Reserved Matters Planning Reference 2017/0135

Barnsley Metropolitan Centre 'Tower Design' Condition

Planning Condition Number 8 Tower Design

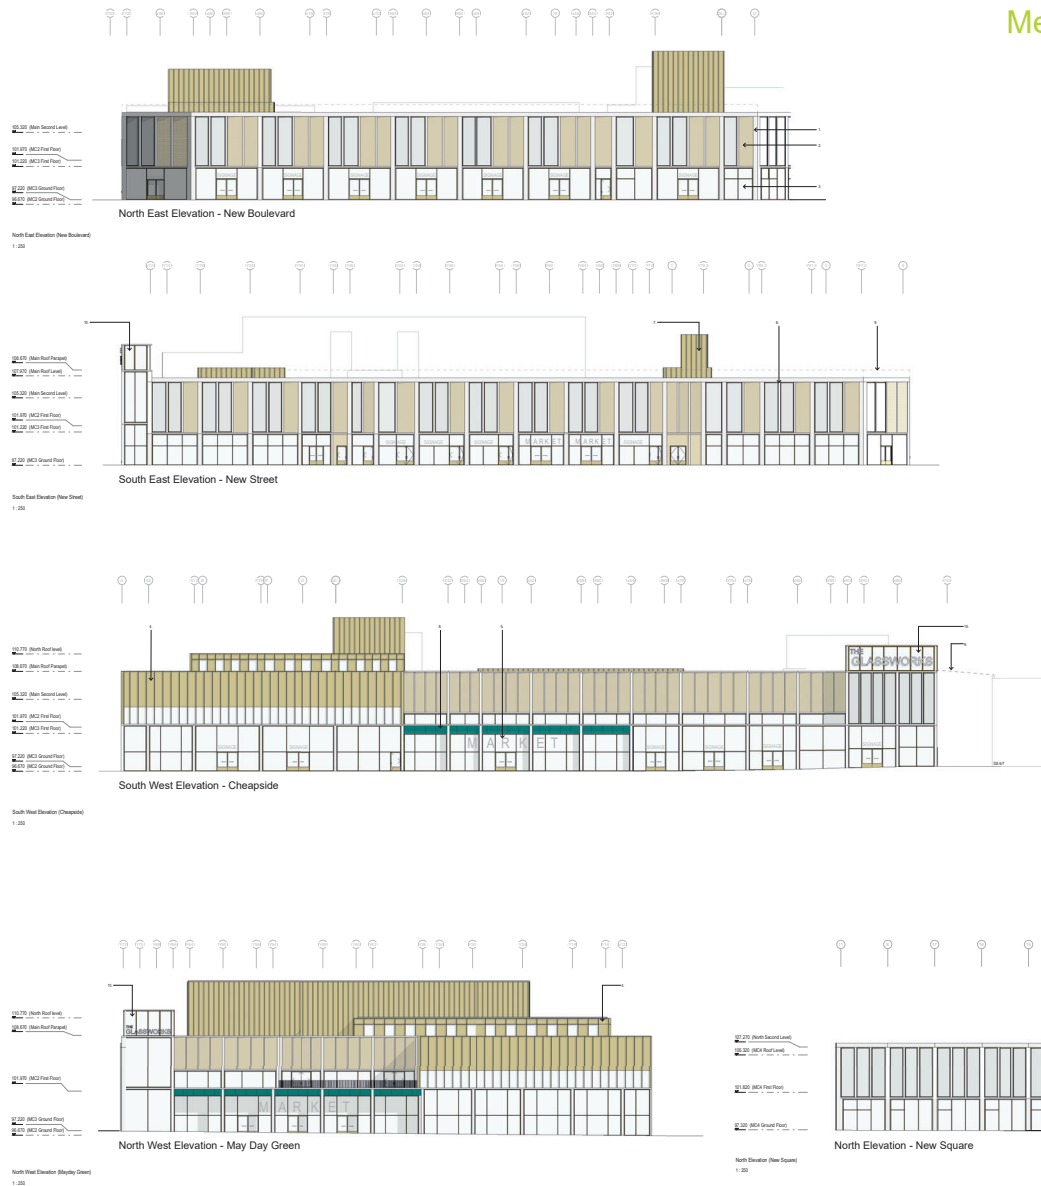
During the design review concern was raised by members of the panel that the face of each elevation has almost become interchangeable. For example you could change the elevation of the cinema to the library- they cancel each other out. It was felt worthwhile to invest in slightly more grand moves in terms of differentiating the civic architecture from the retail/ leisure architecture.

This issue was typified by the box on top of the glass entrance tower. It was felt that this tower needed a more robust design. The ways it sits flush with the corner doesn't help to positively create a welcoming gesture or help to orchestrate the space around it. This element could be more of a counterpoint to the square, through more depth, (with recess and reveals to create more shadow), and through the detailing of its proportions and modelling. Existing examples to look at for inspiration include the Campanile of Barnsley town hall, which helps define the square in front of it as a focal point, towers in Stevenage and Coventry and, further afield, towers in the squares of Venice and Florence. In terms of positive place making and creating reference points for the scheme there is a need to focus on the design of these corner points, (using the architectural advices available in the budget). Don't rely on branding to do this.

Look to articulate the modelling of the entrance towers more. Look to create them as more exciting focal points. Look to design them to more actively define the spaces around them.

As a result of the comments and feedback from the Design Panel, amendments were made to articulate and create exciting focal points to the glass towers.

- Overall building form; advised to give prominence to towers
- Increase height of towers
- Additional mullions added to first floor to articulate against ground floor setting out
- Dimensions of GRC columns and beams refined
- These refinements are demonstrated on the following pages with the before and after visuals for comparison of the glazed towers to May Day Green and Cheapside.
